# Response to Submissions

Chain Valley Colliery - Modification 3 | Mannering Colliery - Modification 5

Prepared for Great Southern Energy Pty Ltd (trading as Delta Coal)  
August 2019

Subject: Mannering MOD 5 – Response to Submissions – Air Quality

Figure 1: Predicted 24-hour average  $PM_{10}$  concentrations at Receptor 4 Project-alone plus background at CVC TEOM ( $\mu g/m^3$ )

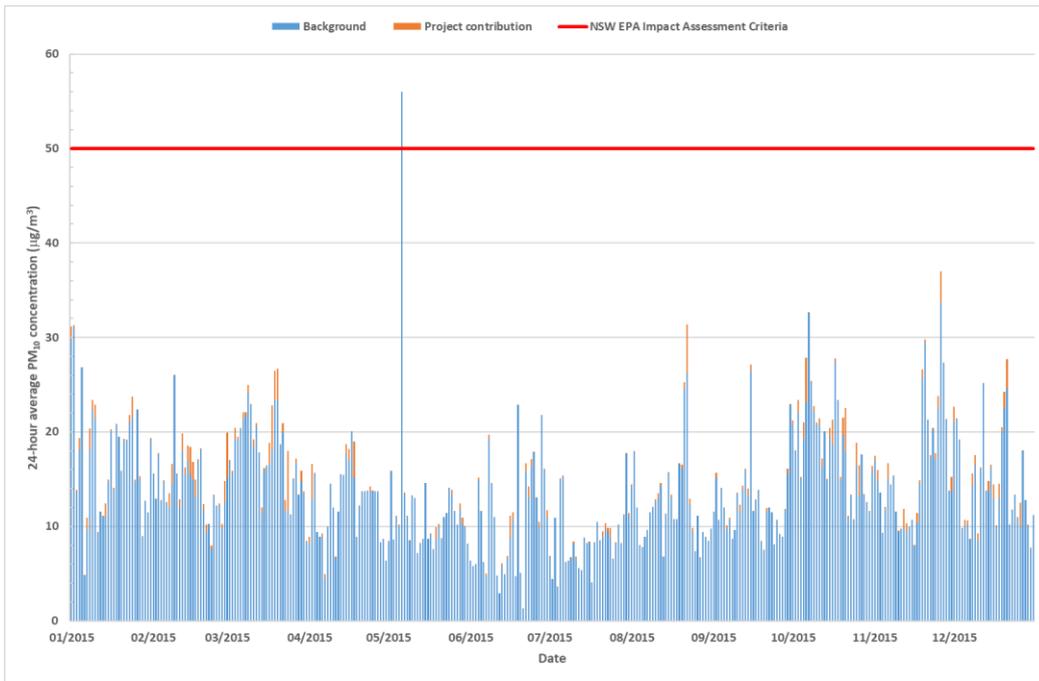
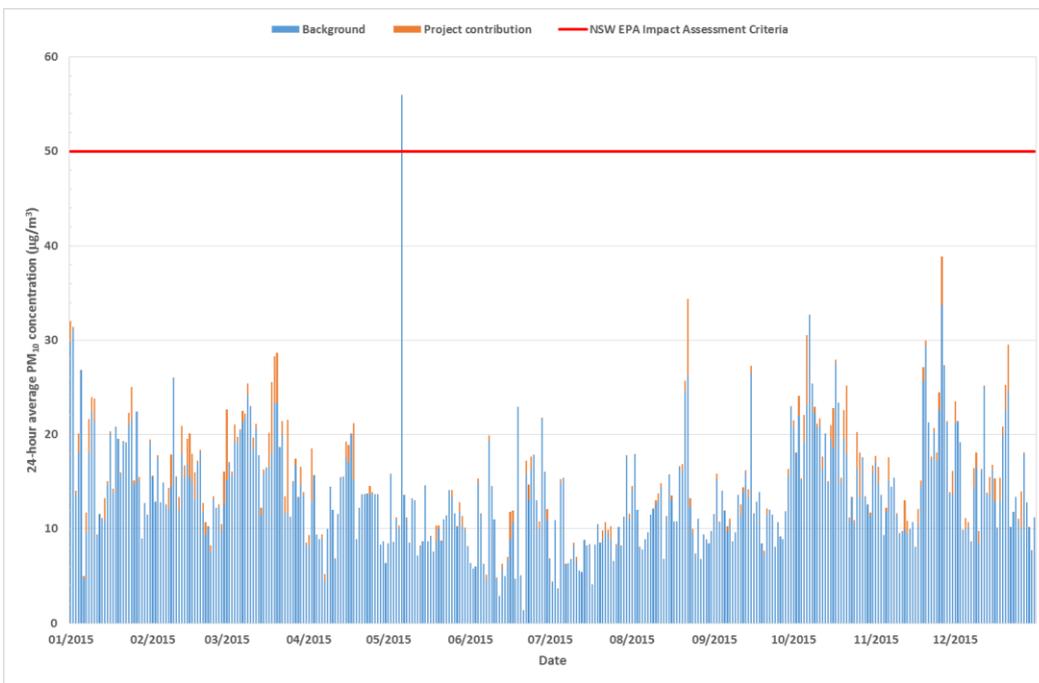
Council seeks clarity on Table 8.5, which predicts an increase in the 24-hour average PM<sub>10</sub> concentrations, but no increase in the "project plus background" value. It is noted that both the existing and proposed values appear to exceed the "Assessment criteria" figure.

- DPIE's submission references the LMCC submission:
  - *LMCC's submission for Mannering Colliery Mannering Colliery Mod 5 seeks clarification on the predicted increases in the 24-hour average PM10 concentrations, as represented in Table 8-5 of the Statement of Environmental Effects. Please provide clarification regarding any predicted air quality exceedances.*

The reason why there is minimal to no change in the cumulative 24-hour average PM<sub>10</sub> concentration is because the maximum cumulative is driven by the existing background concentration, and the maximum predicted concentration from the Project alone does not occur on the same date as the maximum measured background concentration.

This was demonstrated in Figure 8-10 of the AQA that showed the predicted 24-hour average PM<sub>10</sub> contribution from the Project alone (orange bars), together with the corresponding background 24-hour average PM<sub>10</sub> concentration for each day of the year (blue bars) at private receptor (R4). It is apparent that the maximum cumulative concentration is due to the measured background concentration on 6 May of 56.0 µg/m<sup>3</sup>. The New South Wales Air Quality Statement 2015 (NSW OEH, 2016) states that a dust storm occurred on 6<sup>th</sup> May. Approximately 99% of the measured 24-hour average PM<sub>10</sub> concentrations are below 30 µg/m<sup>3</sup>.

On the same date, the predicted contribution from the Project alone is small (for the Proposed project this is a maximum of 5% at R8) when compared with the background. Hence the reason the data presented in Table 8.5 of the AQA (shown as Table 1 above) shows minimal (if any) change in the predicted cumulative concentrations between the existing and proposed operations.

This is further demonstrated in Figure 1 to Figure 9 which show the predicted 24-hour average contribution from the Project alone (orange bars) and the corresponding background 24-hour concentration (blue bar) for each day of the year at all receptors.
